F/YR25/0925/F

Gaultree Farm, High Road, Guyhirn, Wisbech Cambridgeshire PE13 4EA

Erect 4 x dwellings and the formation of an access involving the demolition of existing dwelling and outbuildings

Officer recommendation: Refuse

Site Plan
Scale: 1:200

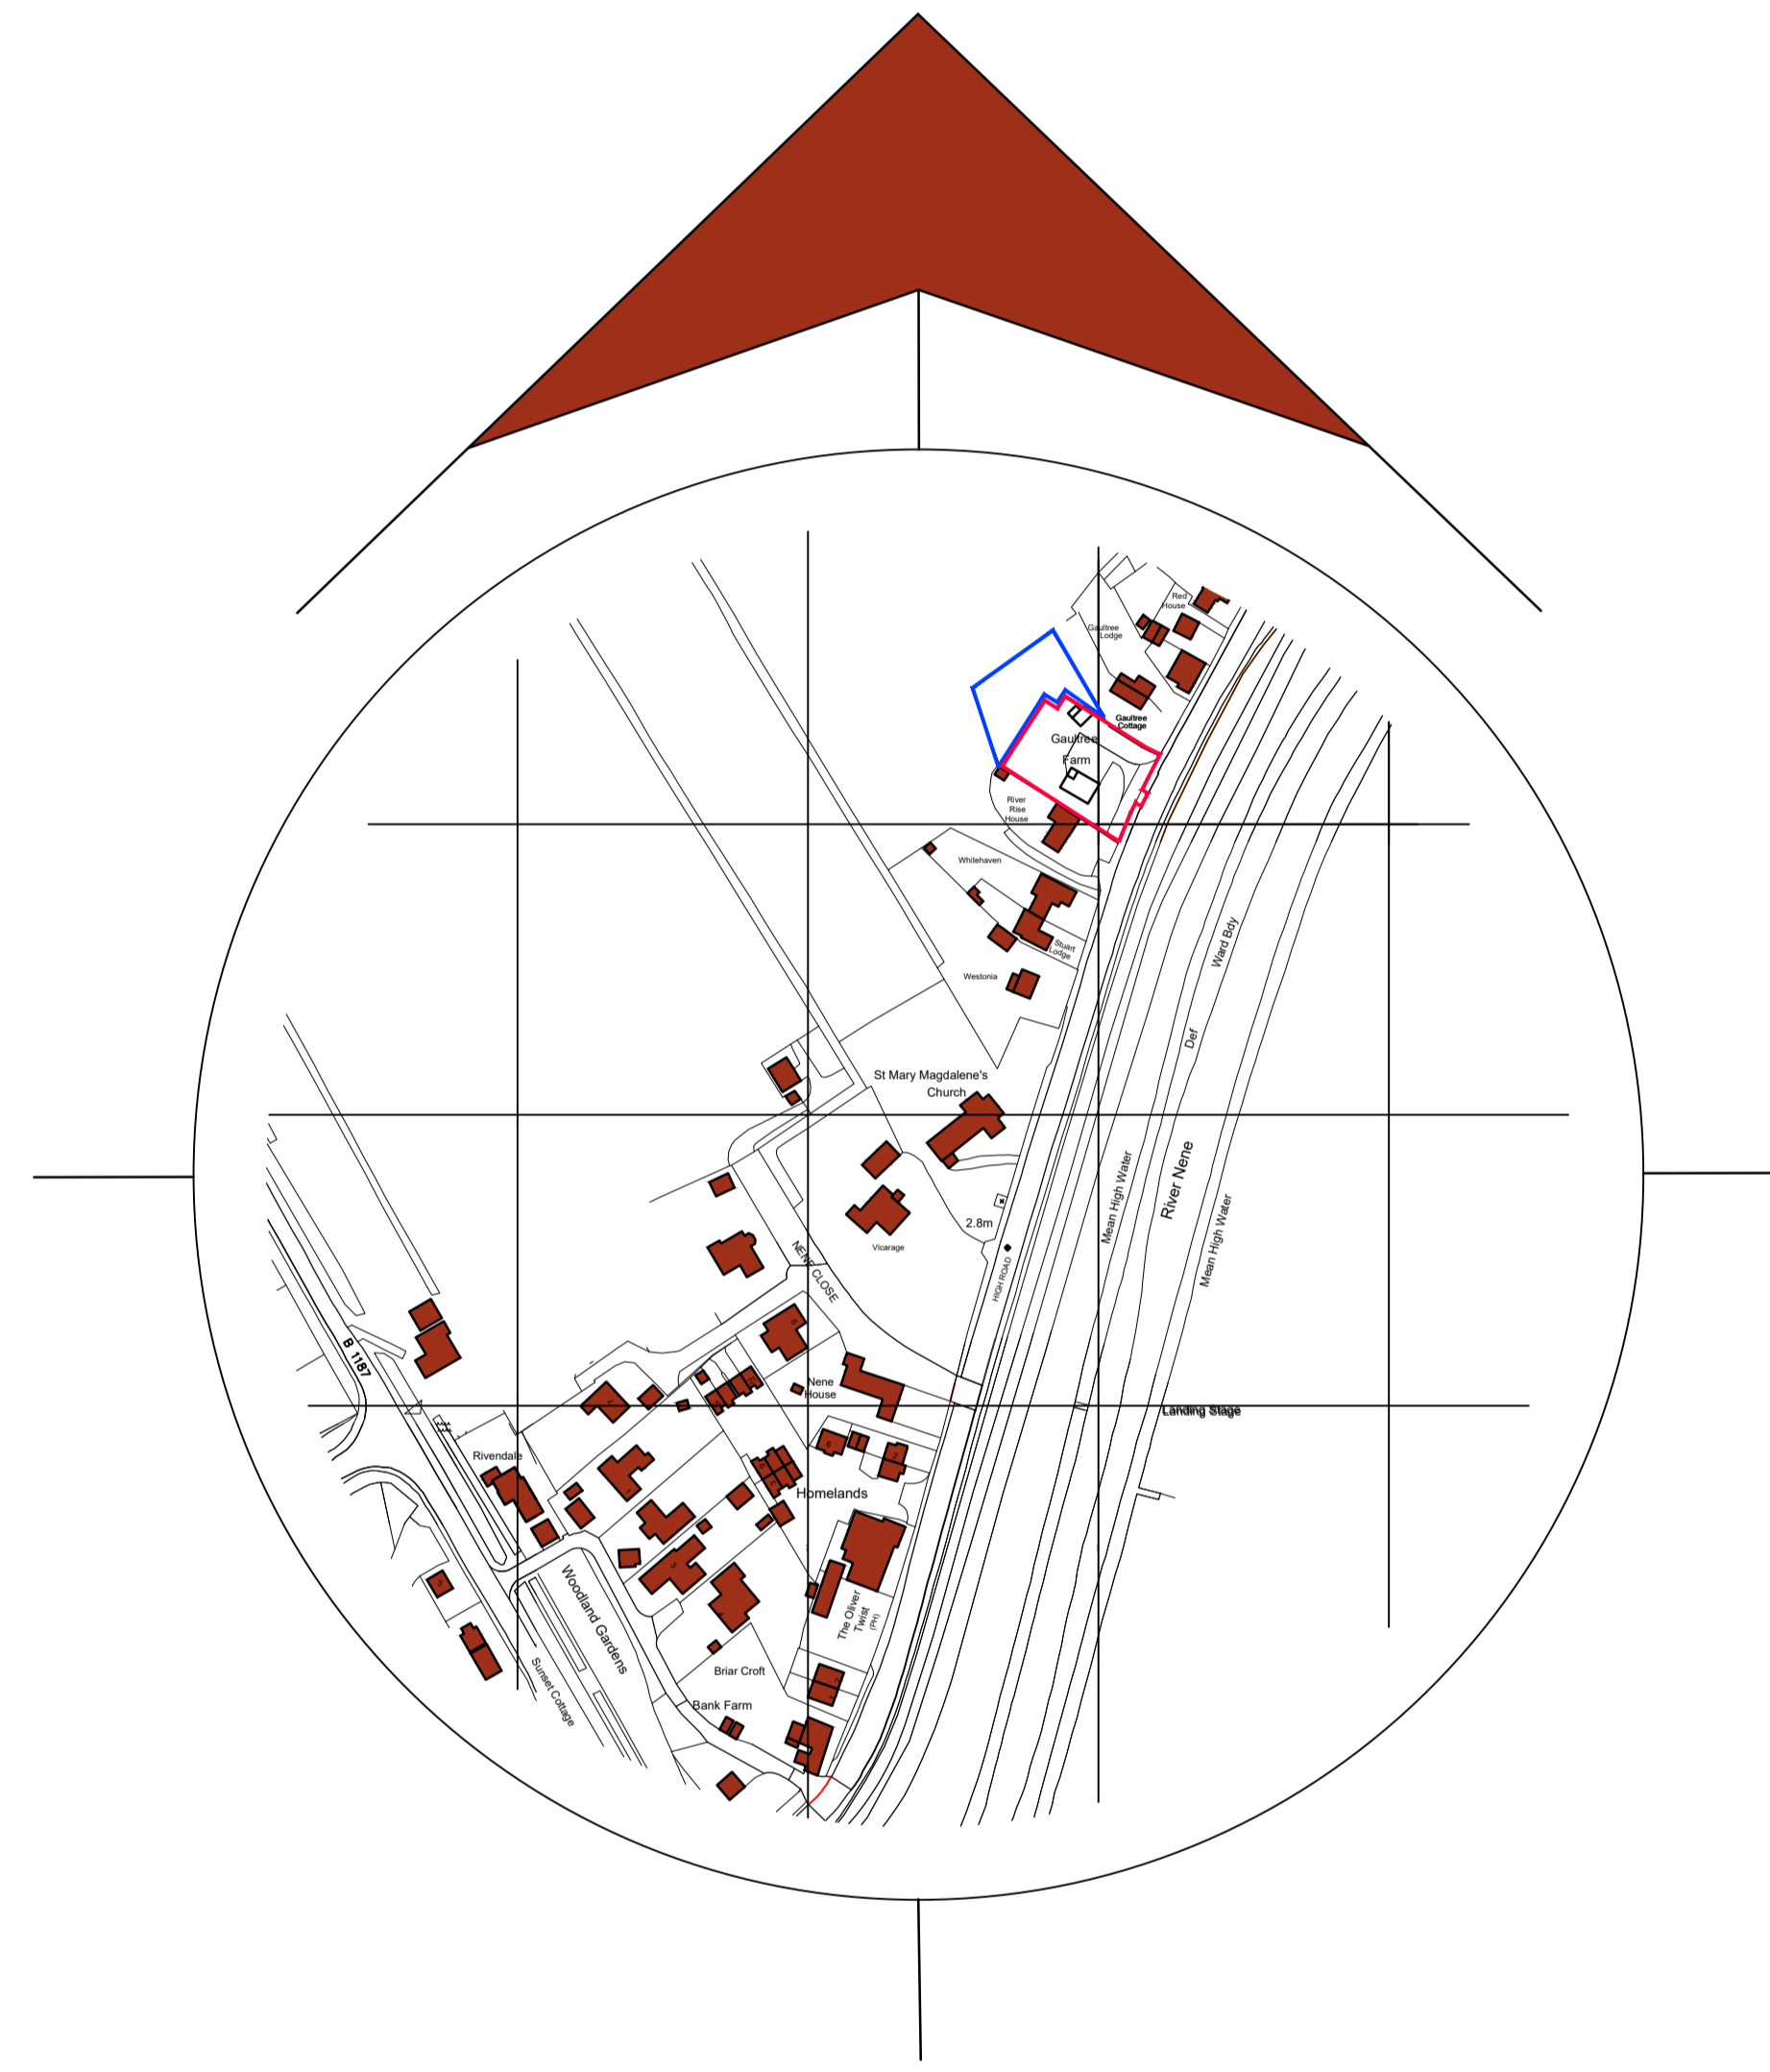
The development benefits from an existing dropped kerb with the highway. There is good visibility in either direction of the proposed access. The applicant has included what appears to be an adequate turning facility within the site so vehicle can enter the highway in a forward gear. However, the dimensions / size of the vehicle shown (presumed standard FDC refuse vehicle) is not shown. Therefore, I would recommend that the planning authority are satisfied that this facility is adequate for FDC refuse vehicles prior to the determination of this application.

10.15. In addition, concerns relate to the overall amenity quality of the development. Policy LP16 (h) requires new development schemes to set aside a minimum of a third (33%) of the plot curtilage as private amenity space. The current proposal underdelivers for each plot, with useable amenity space (i.e. the main garden areas) calculated as follows:

Plot	Plot Curtilage (m ²)	Useable amenity space (m ²)	Percentage of total plot (%)
1	261.68	76.13	29
2	201.17	61.84	28
3	221.21	57.78	29
4	261.31	64.60	26

10.16. Furthermore, the scheme includes both front and rear parking areas, which will dominate the outlook for both pairs to the streetscene, but will be particularly notable from the main habitable living rooms of plots 2 & 3.

- 10.19. The submitted layout plan shows that dwellings will be accessed by a central shared access driveway leading to parking for each dwelling and a shared turning area. The scheme also indicates provision for parking of 2 cars within the rear parking areas, with an additional space per dwelling provided to the front. As such, notwithstanding the position of parking considered above that may affect outlook, the scheme offers an appropriate quantum parking which is consistent with the required provision within the Fenland Parking Standards for 4-bedroom dwellings.
- 10.20. The development has been considered by the CCC Highway Authority, and no objections have been raised subject to the imposition of relevant conditions.
- 10.21. As such, the scheme is considered acceptable, on balance, with respect to Policy LP15, subject to conditions.

Ground Floor Plan
Plots 183 - Scale: 1:100

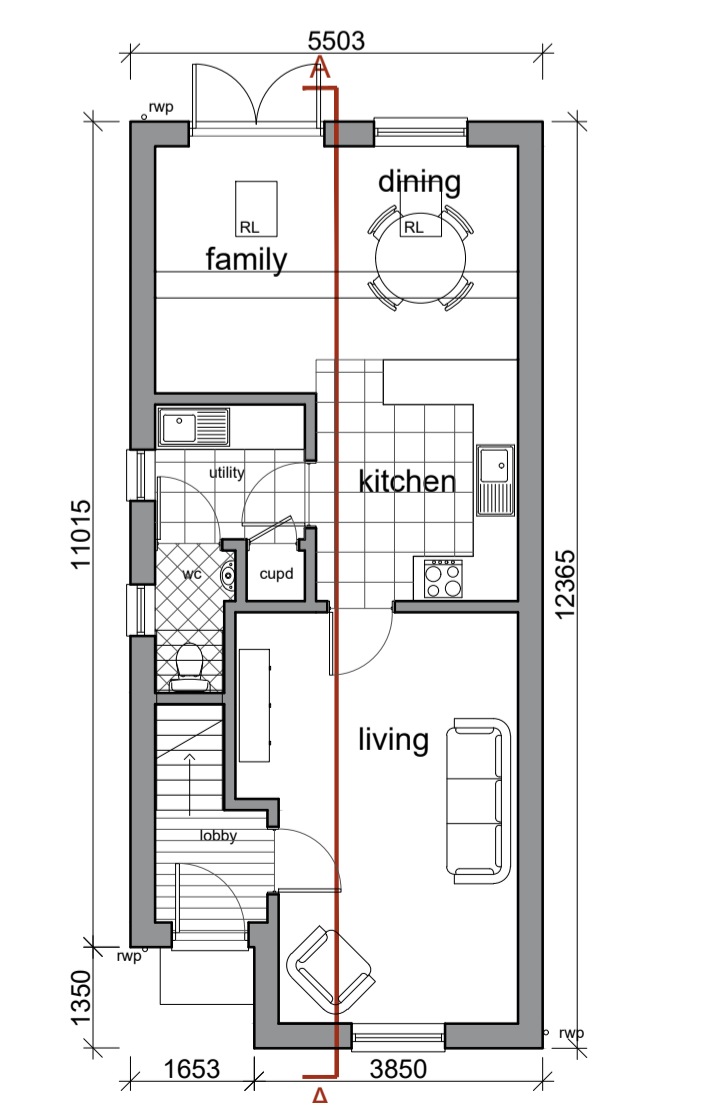
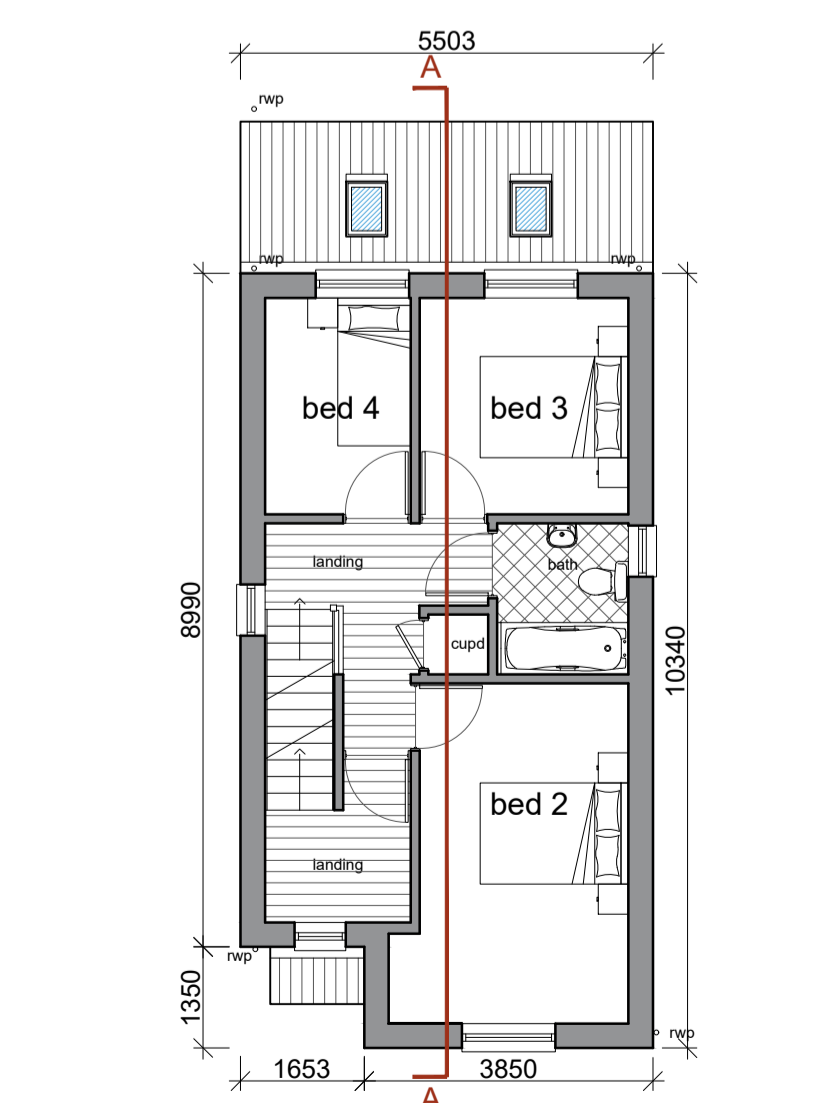
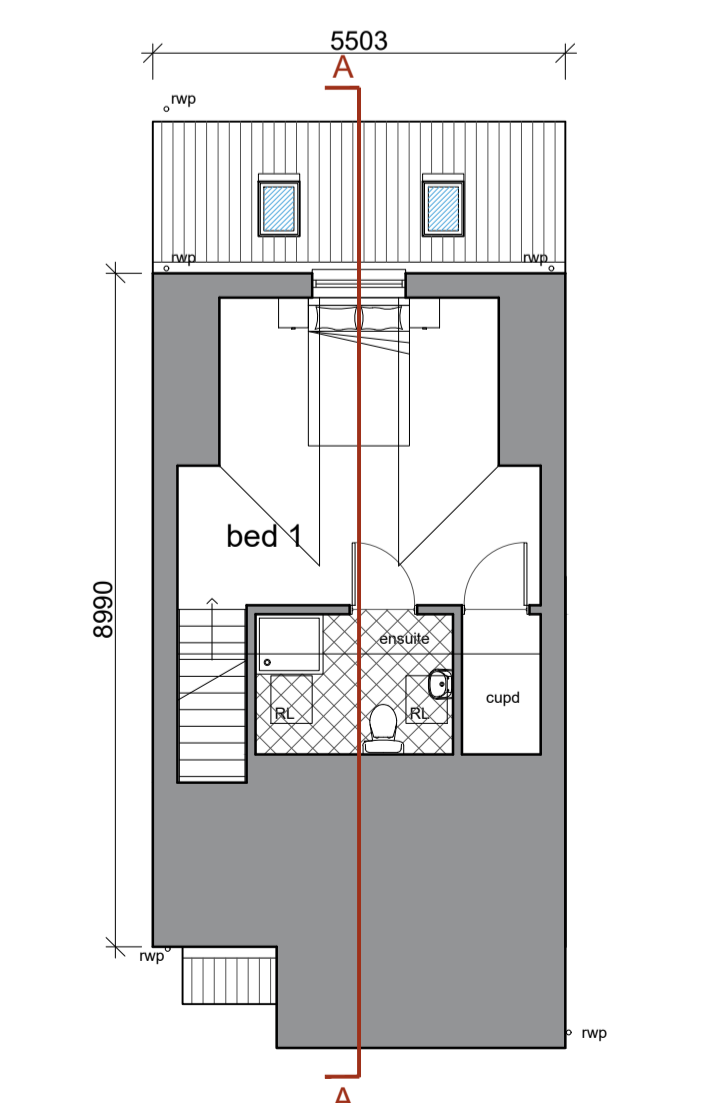
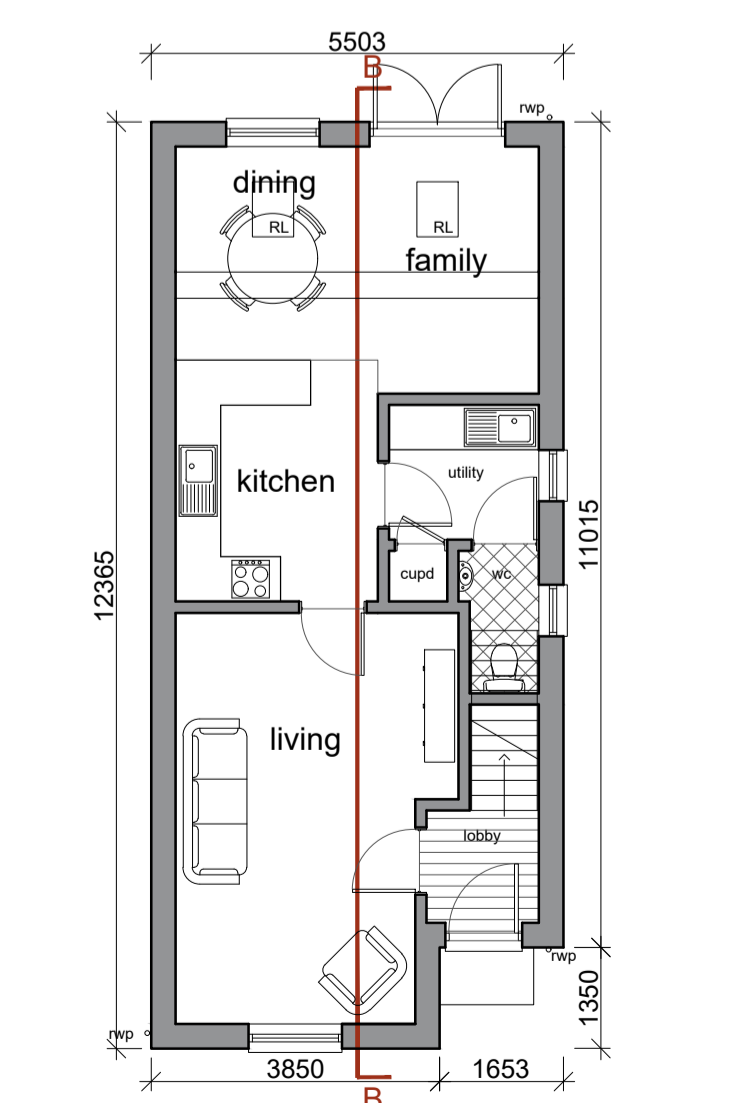
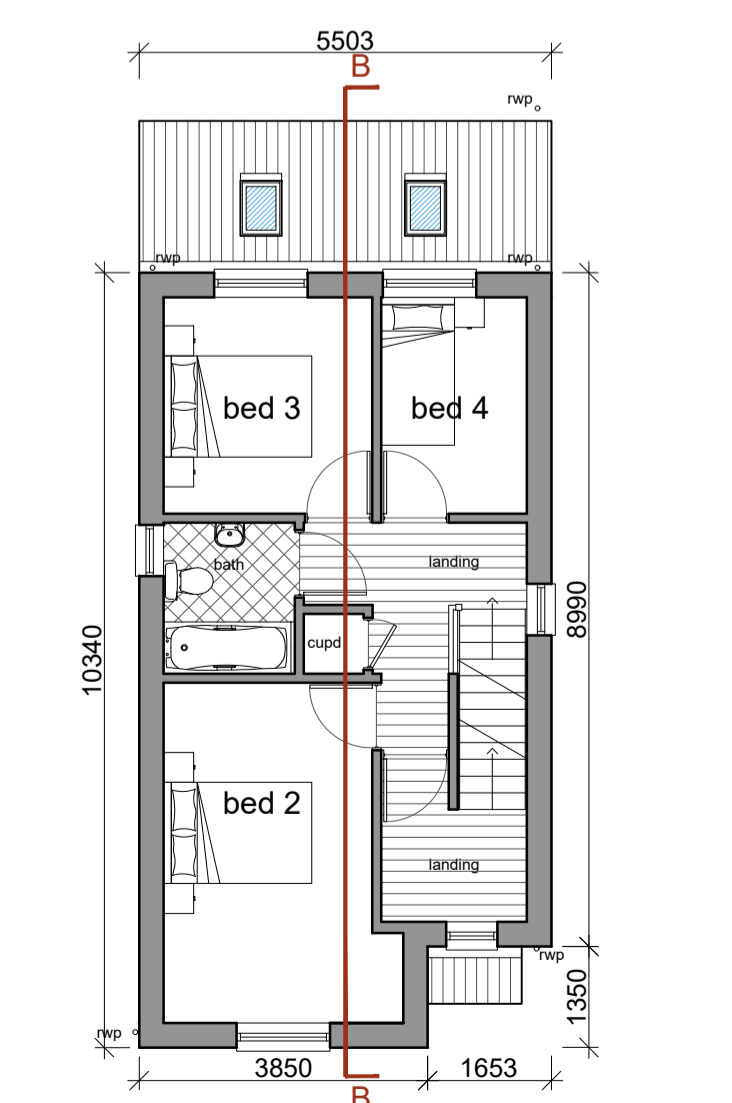
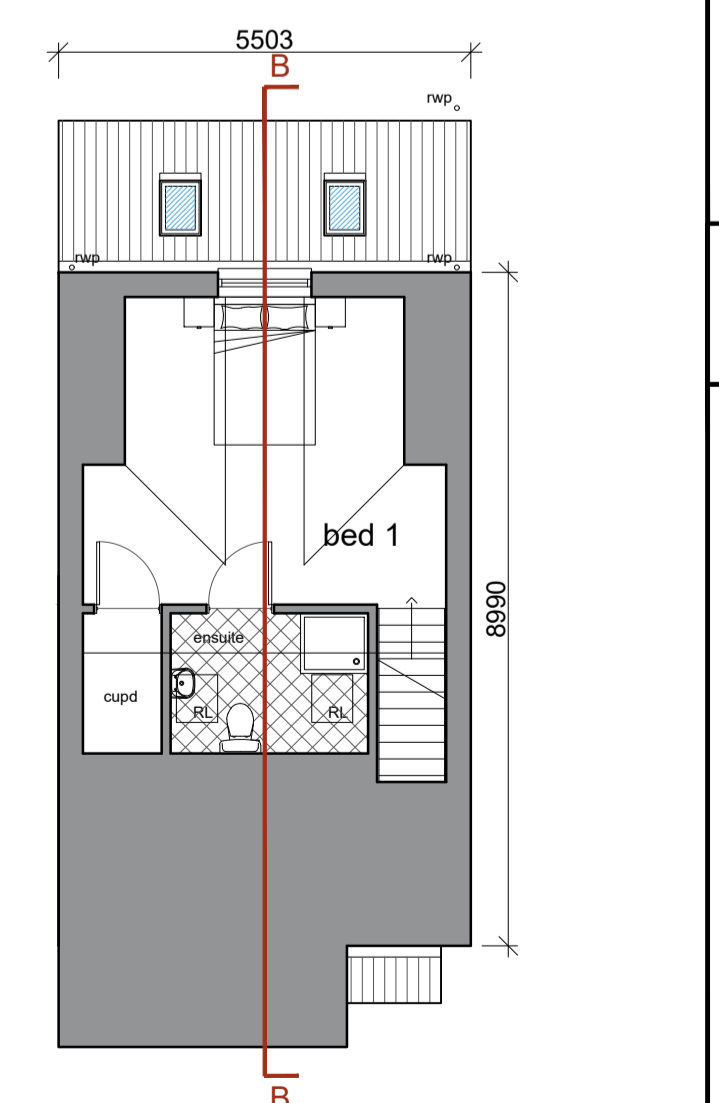
Min width (m)	Floor Area (m ²)	Compliant
Bedroom 1 (1 st double)	3.698	17.18	Yes
Bedroom 2 (2 nd double)	2.762	12.84	Yes
Bedroom 3 (3rd double)	2.762	7.60	No
Bedroom 4 (Single)	1.930	5.45	No
GF Floor Area		53.31	
FF Floor Area		43.69	
SF Floor Area		26.63	
Total Gross Floor Area		123.63	Yes

10.14. Accordingly, it can be seen that two of the bedrooms within each dwelling are below the recommended minimum space standards, and as such would result in a cramped living arrangement for future occupants within the dwellings.
